FPP Change Form

Change Request Number: 11LMN003_Spill Change for Navigation Safety

Date: October 28, 2010

Figure 1. Lower Monumental Incident Diagram.

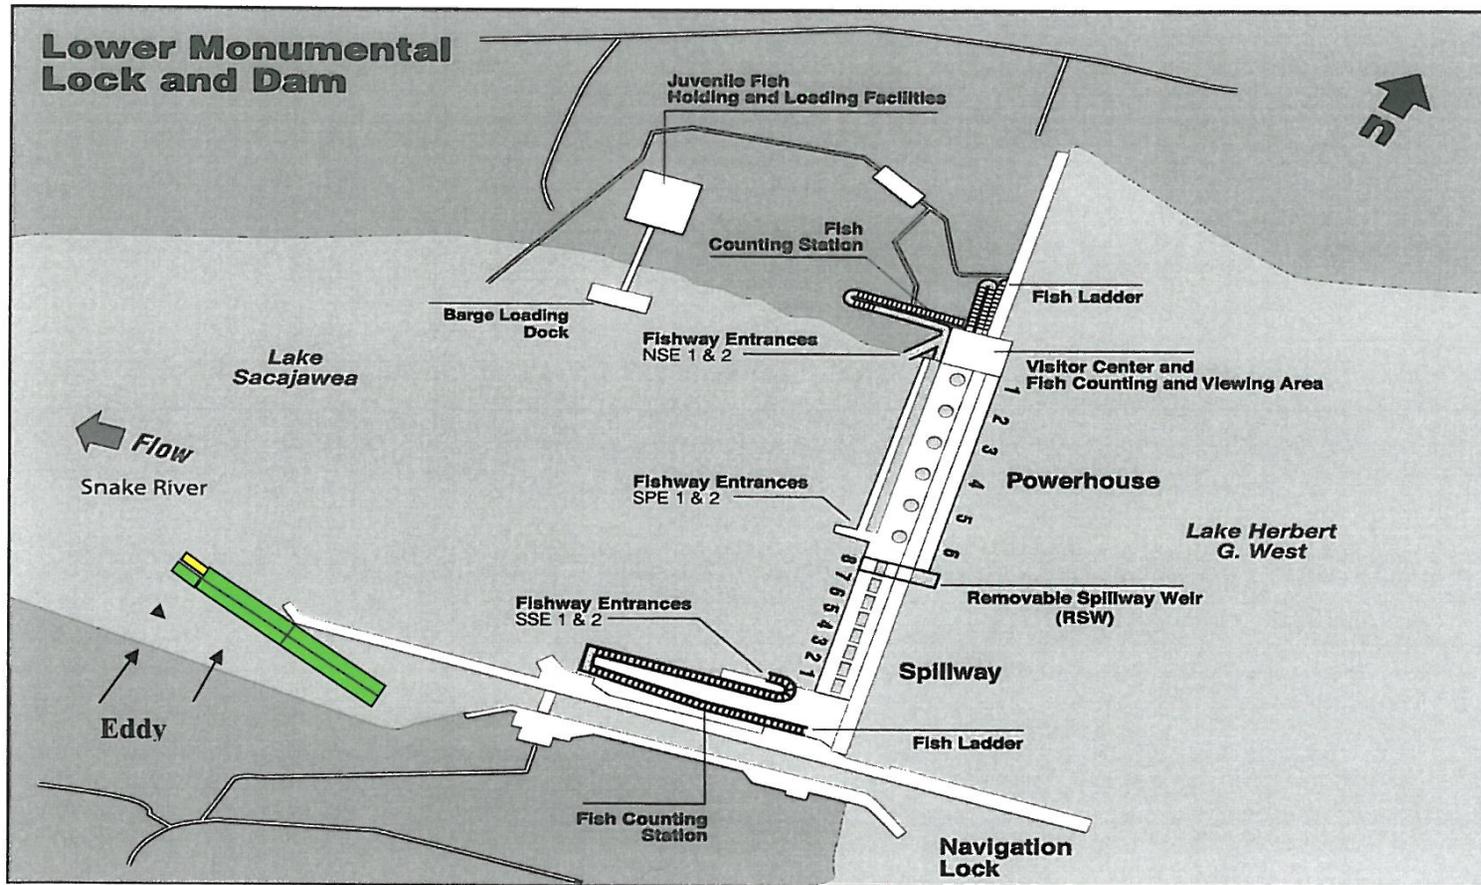
1. Upon approach to the lower basin (lock entrance), eddy currents forced the bow of the tow towards the outer (north) guide wall. The tug had to burn to get the tow around the corner of the guide wall and safely into the lower basin. Figure 1 shown on page 4 shows the angle of the barges on the approach.

2. Tug Capt. Bob also had a full tow but with a loaded chip barge (wood product). Capt. Bob had basically the same approach as Defiance incident in 1.), above. The operator had to steer towards the south bank to keep the bow of the tow on the good side of the lower basin. This action forces the stern section of the tow to swing to the north which produces the angle you see in the diagram (Figure 1).

Incident Details: The tug Defiance was making an approach into the lower basin of Lower Monumental Dam. Total flow was 34 kcfs with 17.40 spill. The tow consisted of 5 barges, one being a loaded fuel barge. As the tow was lining up to enter the lower basin the eddy created by the low flow and spill gate configuration began pulling the bow of the tow towards the end of the guide wall. The tug (in yellow) had to bend the tow around the end of the guide wall to get into the lower basin. The barge directly in front of the tug was the loaded fuel barge. The operator had to make an evasive maneuver to keep the fuel barge from coming into contact with the wall and get safely into the lower basin.

Figure 2. Lower Granite Incident Diagram.

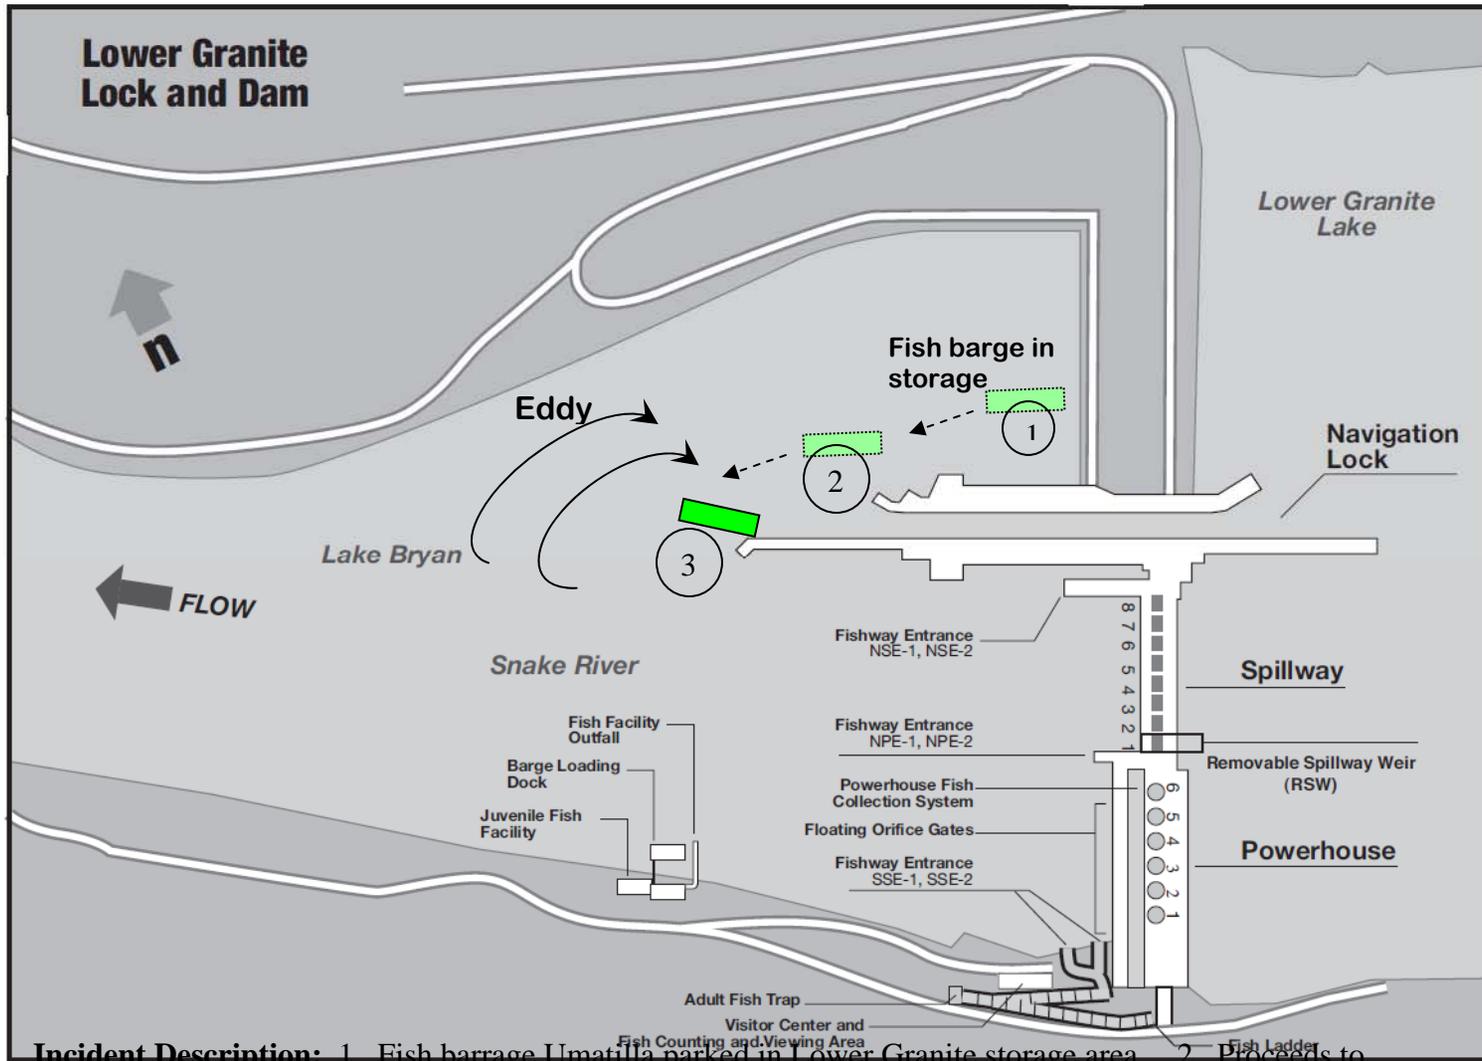
1. Umatilla 8106 fish barge backing out of storage area at Lower Granite collided with guide wall when rounding corner tip of wall (See Figure 2 on page 5). Note that incident details were compiled from dam operator, awaiting official incident report.
2. Cruise vessel possibly entering upper navigation lock and struck guide wall. Details will be finalized after official incident report is completed.
3. No known difficulties.

Incident Description: 1. Fish barge Umatilla parked in Lower Granite storage area. 2. Proceeds to back out of storage area and maneuver to juvenile fish facility on south shore. 3. Eddy current forces starboard side bow into guide wall
